State of Hawaii
DEPARTMENT OF LAND AND NATURAL RESOURCES
ENGINEERING DIVISION
1151 Punchbowl Street, Room 221
Honolulu, Hawaii 96813

ADDENDUM NO. 2

Job No. F48C612A
Keaiwa Heiau State Recreation Area Water System Improvements
Aiea, Hawaii

May 19, 2026

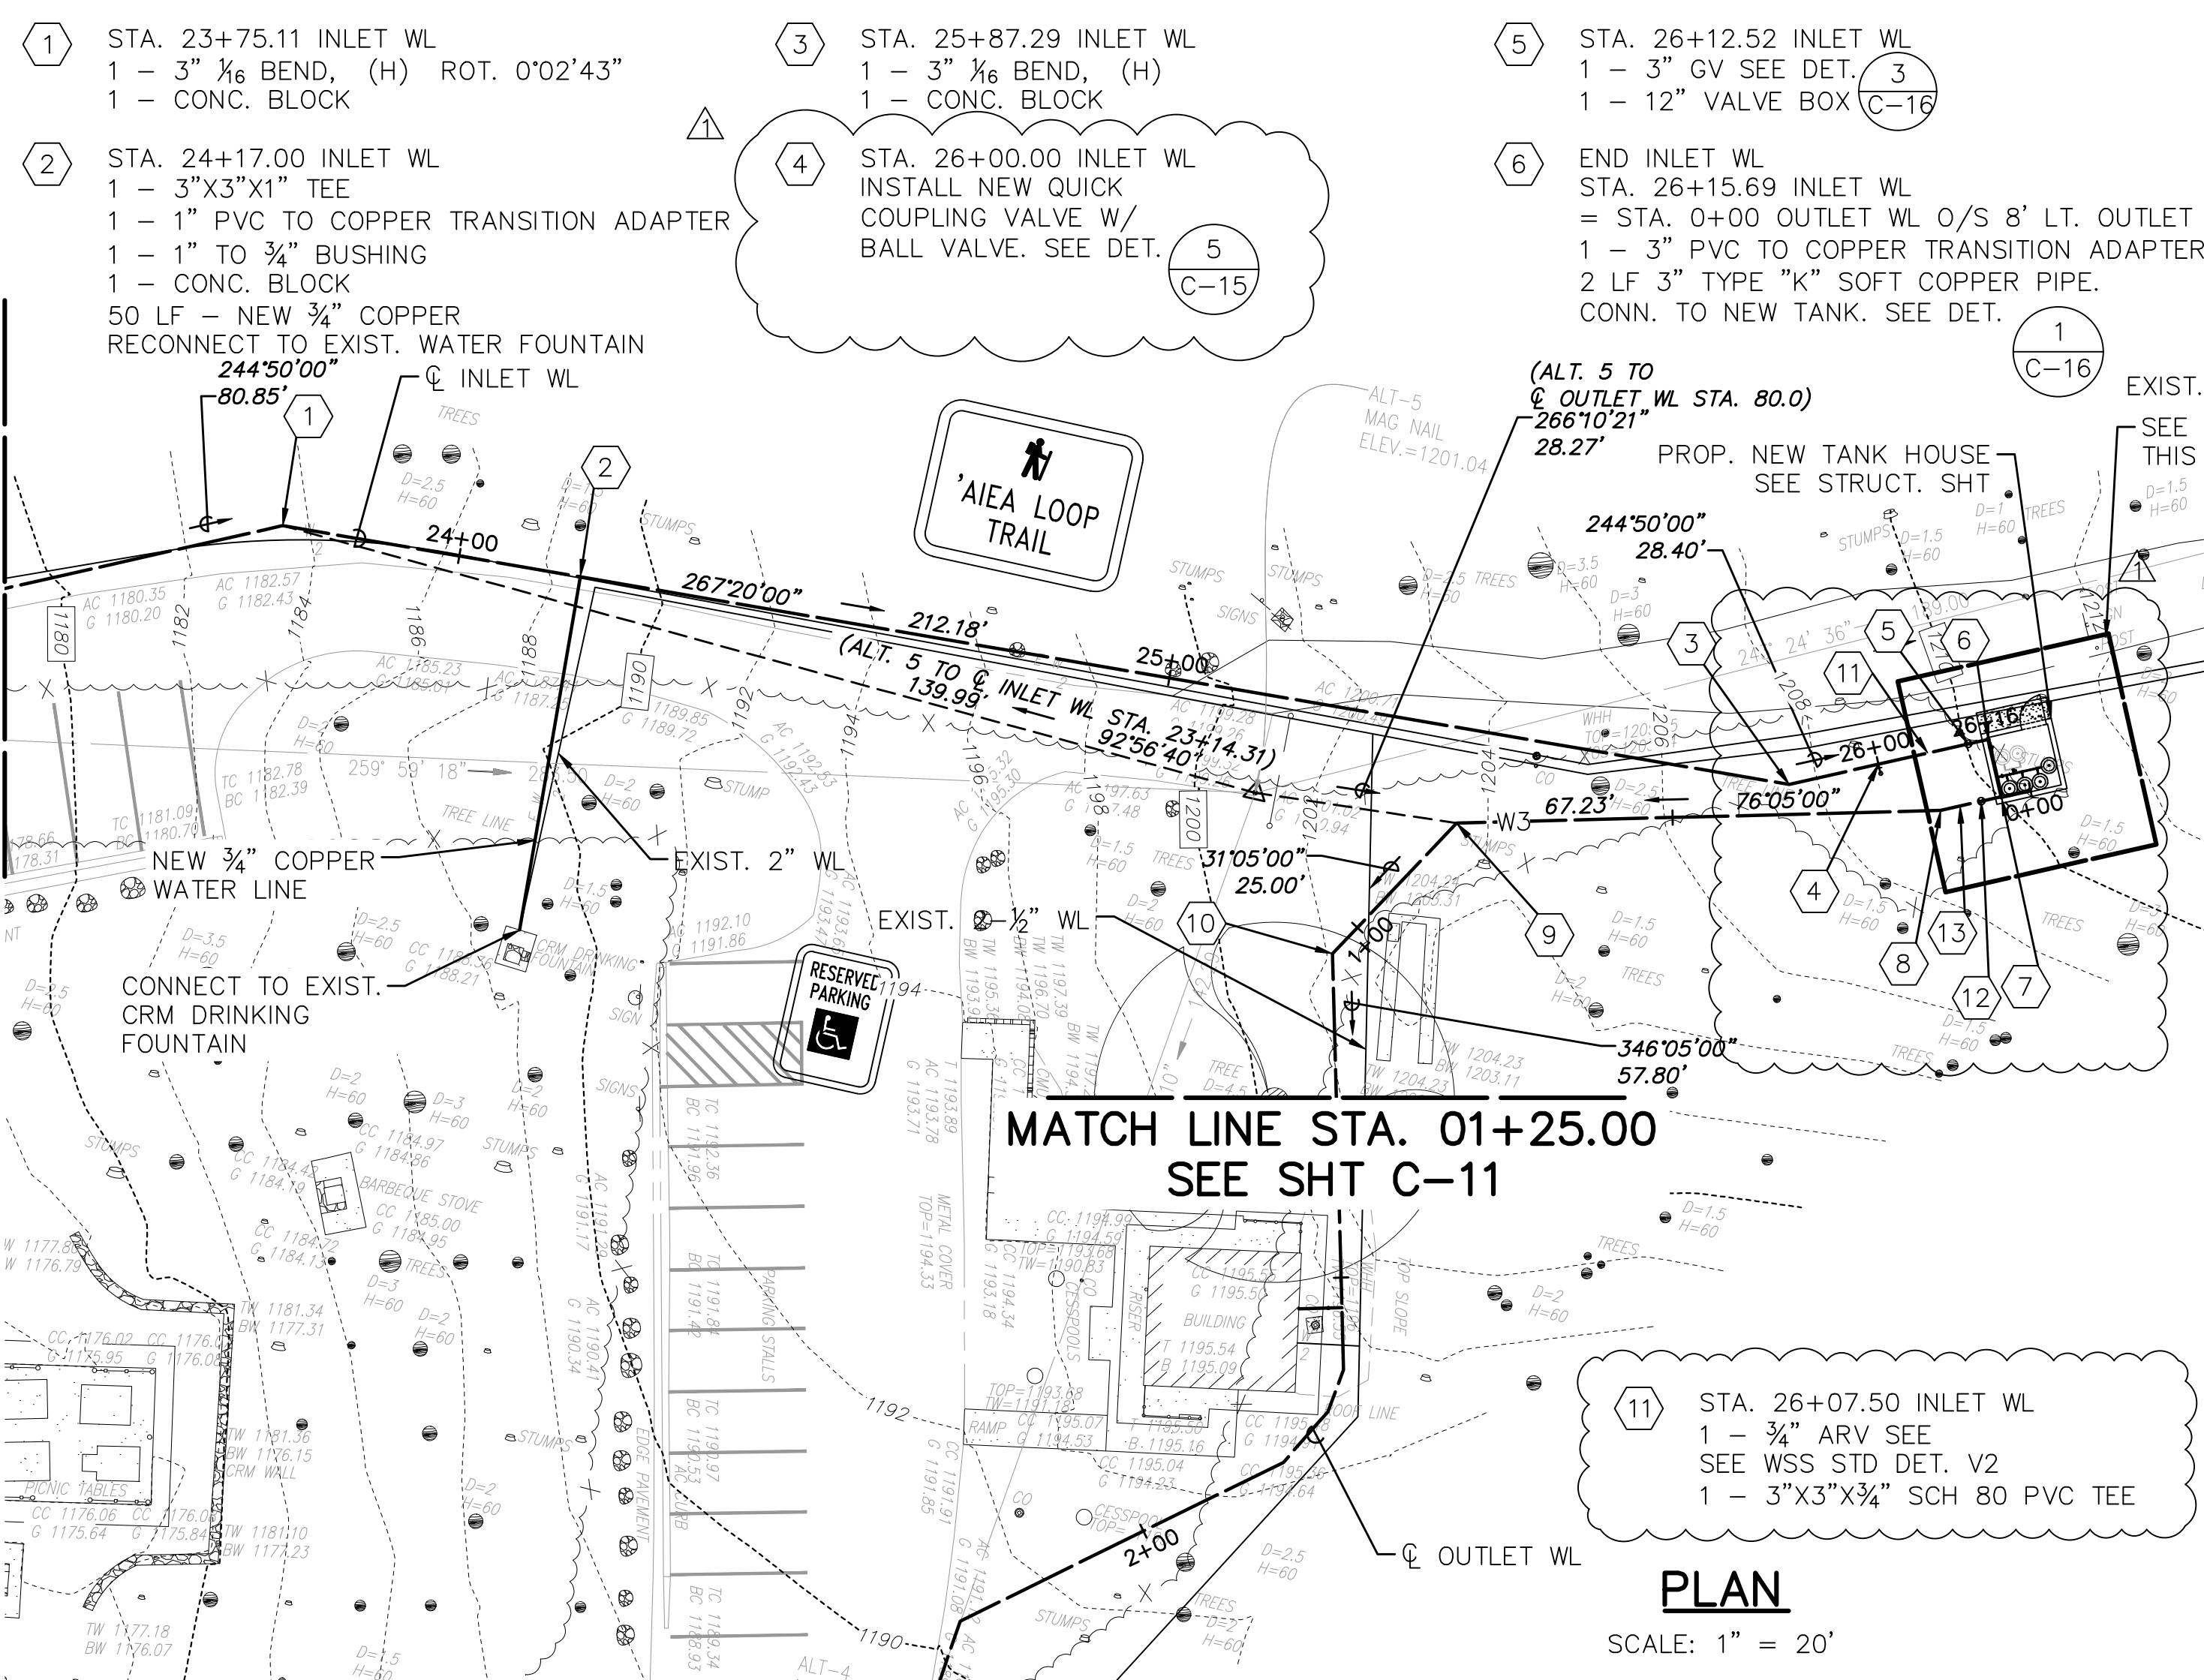
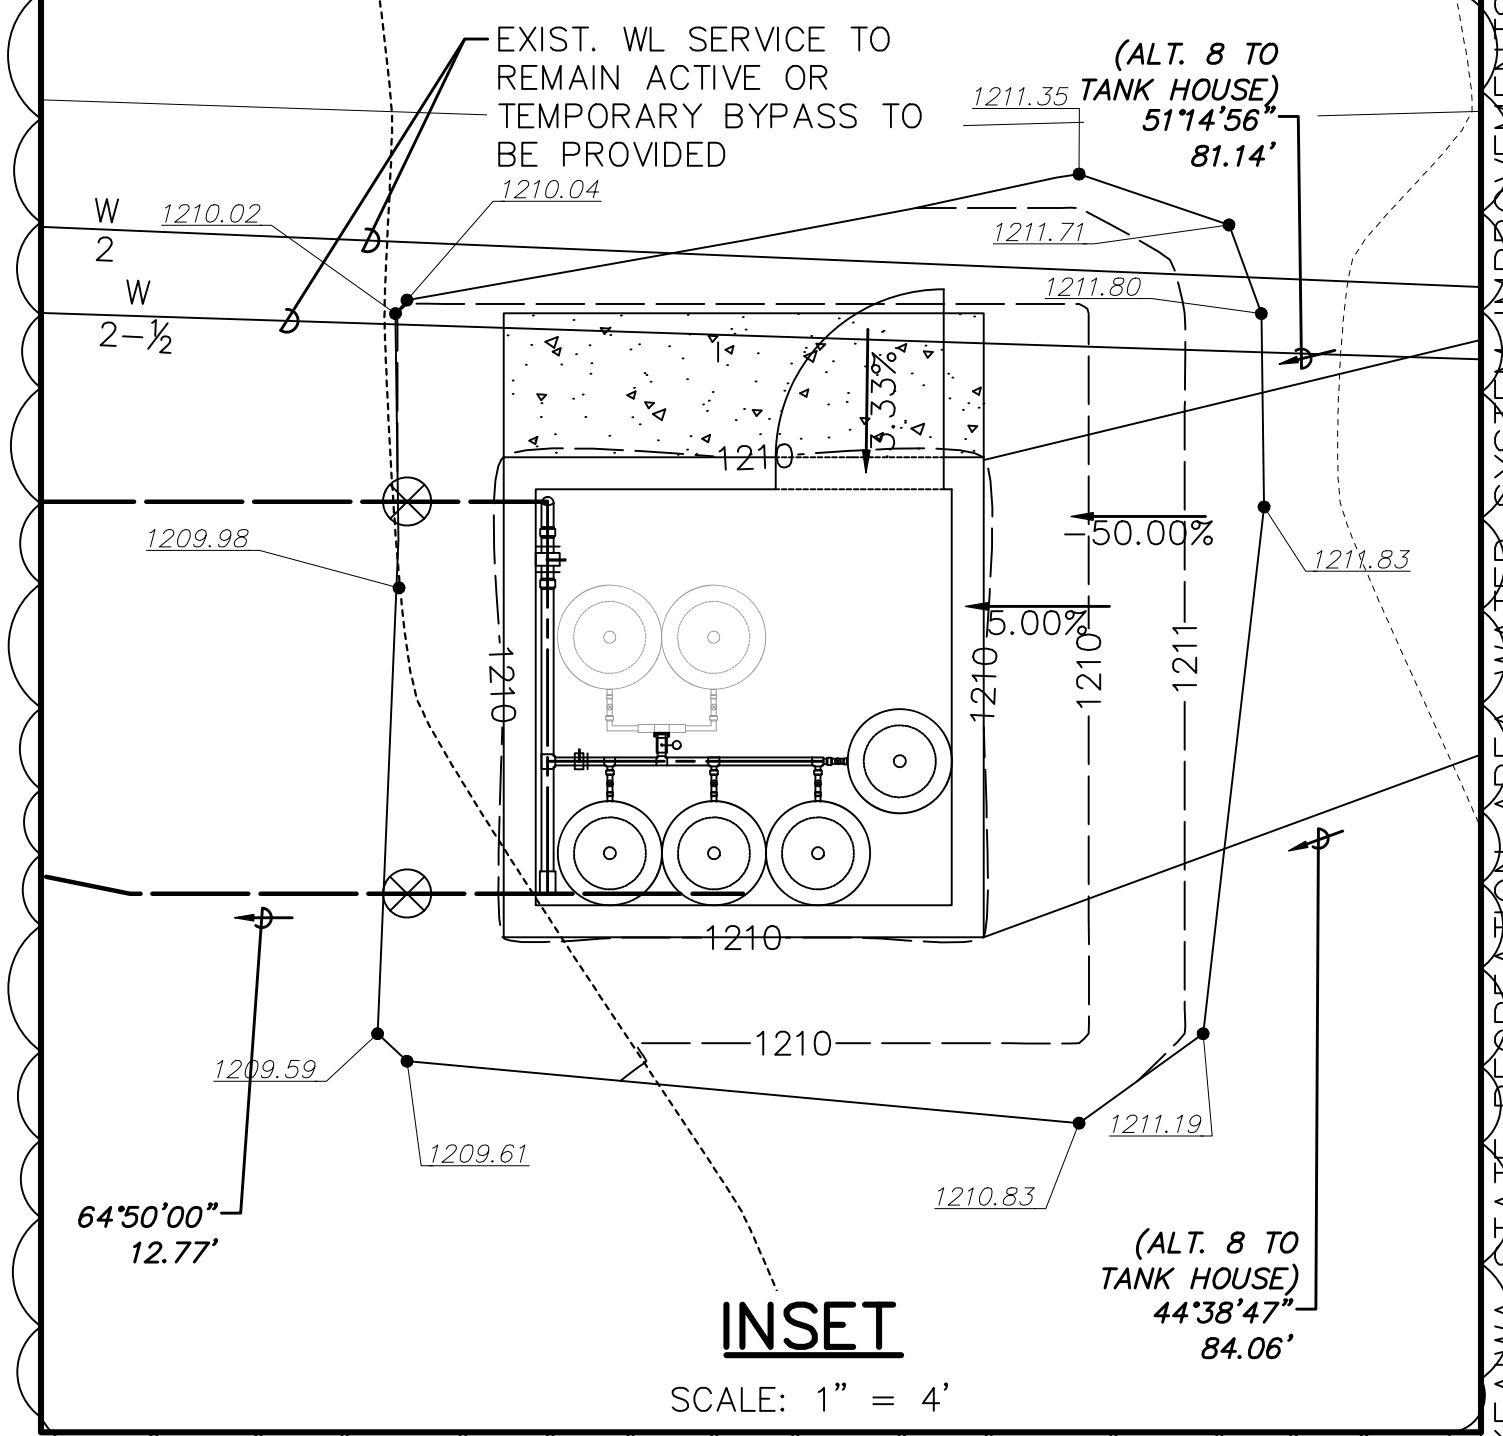
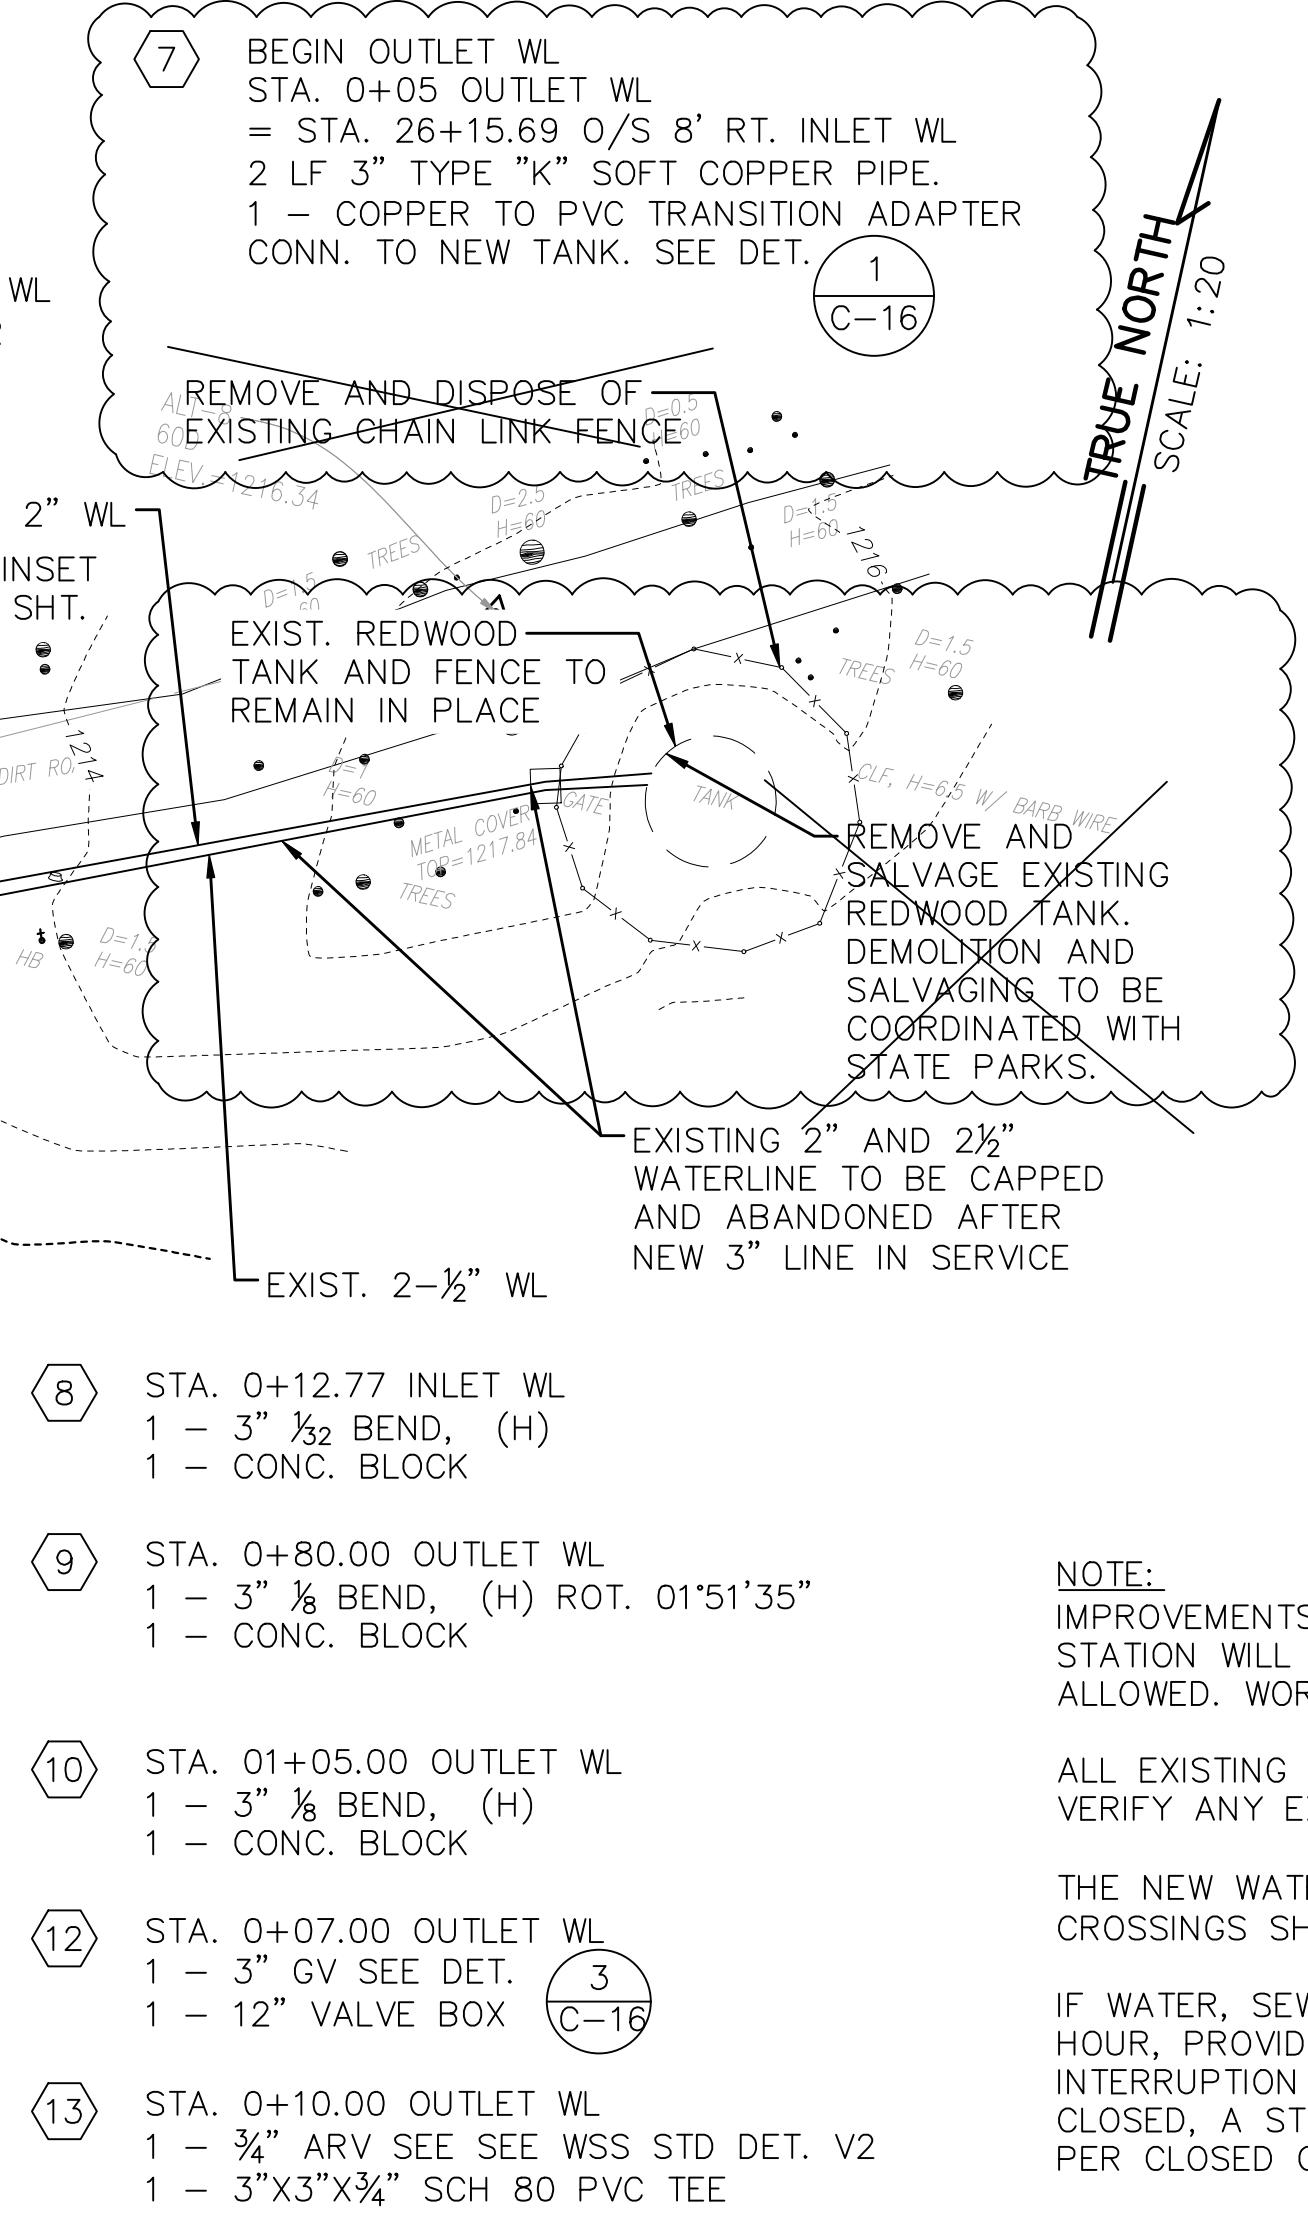
5. Sheet C-9 – Plan & Profile 4, Replace sheet with the attached revised Sheet C-9.
 - a. Added new quick coupling valve.
6. Sheet C-10 – Plan & Profile 5, Replace sheet with the attached revised Sheet C-10.

- a. Added new quick coupling valve.
 - b. Added new air relief valve.
 - c. Revised piping and tanks for bladder tank area.
 - d. Revised existing redwood tank structure to remain in place.

- 7 BEGIN OUTLET WL
 STA. 0+05 OUTLET WL
 = STA. 26+15.69 O/S 8' RT. INLET WL
 2 LF 3" TYPE "K" SOFT COPPER PIPE.
 1 - COPPER TO PVC TRANSITION ADAPTER
 CONN. TO NEW TANK. SEE DET. (1)
 C-16
- 8 STA. 0+12.77 INLET WL
 1 - 3" 1/2 BEND, (H)
 1 - CONC. BLOCK
- 9 STA. 0+80.00 OUTLET WL
 1 - 3" 1/2 BEND, (H) ROT. 01°51'35"
 1 - CONC. BLOCK
- 10 STA. 01+05.00 OUTLET WL
 1 - 3" 1/2 BEND, (H)
 1 - CONC. BLOCK
- 11 STA. 26+07.50 INLET WL
 1 - 3/4" ARV SEE
 SEE WSS STD DET. V2
 1 - 3"x3"x3/4" SCH 80 PVC TEE
- 12 STA. 0+07.00 OUTLET WL
 1 - 3" GV SEE DET. (3)
 1 - 12" VALVE BOX (C-16)
- 13 STA. 0+10.00 OUTLET WL
 1 - 3/4" ARV SEE SEE WSS STD DET. V2
 1 - 3"x3"x3/4" SCH 80 PVC TEE
